UNITED STATES PATENT AND TRADEMARK OFFICE

APPLICATION NO.	FILING DATE	FIRST NAMED INVENTOR	ATTORNEY DOCKET NO.	CONFIRMATION NO.
10/507,453	09/13/2004	Gerd Reime	REP-0027	1401
23413	7590	04/18/2006	EXAMINER	
CANTOR COLBURN, LLP 55 GRIFFIN ROAD SOUTH BLOOMFIELD, CT 06002			DOAN, JENNIFER	
			ART UNIT	PAPER NUMBER
			2874

Office Action Summary

DETAILED ACTION

FIG. 9

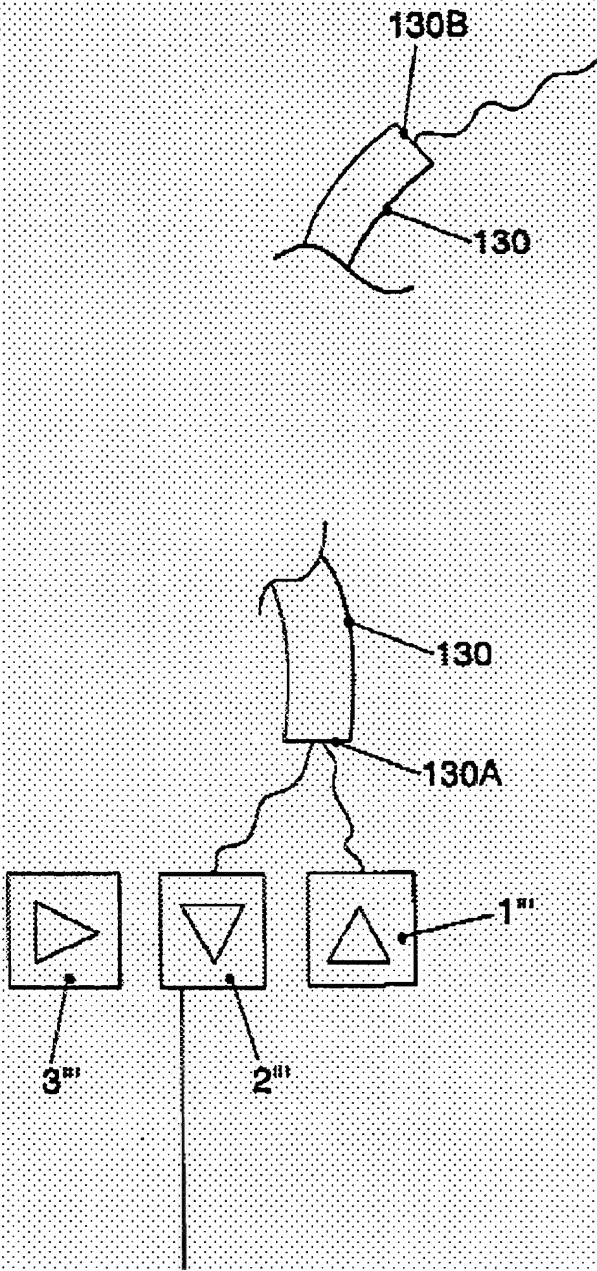
With respect to claims 26, 42 and 43, Reime (figure 9) discloses a method and a device for optoelectronically detecting movement and/or position of an object comprising at least one transmitting element (1'') for emitting radiation in the optical wavelength range and at least one receiving element (2'') for receiving at least a part of the radiation emitted by the transmitting element and reflected back by the object and also comprising an optical guide (130) arranged in the beam path between the transmitting element and the receiving element, wherein the optical guide (130) comprises at least one light coupling element for coupling-in the radiation previously radiated through the optical guide and diffusely scattered at the object; wherein the radiation is light (see paragraphs [0012], [0080] and [0081]).

With respect to claims 28 and 45, Reime (figure 9) discloses a method and a device, wherein the radiation radiated through the optical guide (130) by the transmitting element (1'') is radiated transversely through the optical guide from the side opposite the object (see paragraph [0081]).

With respect to claims 29 and 46, Reime (figure 9) discloses a method and a device, wherein radiation emitted along the optical guide by the transmitting element is at least partially coupled-out of the optical guide by the at least one light coupling element before it is scattered by the object (see paragraph [0081]).
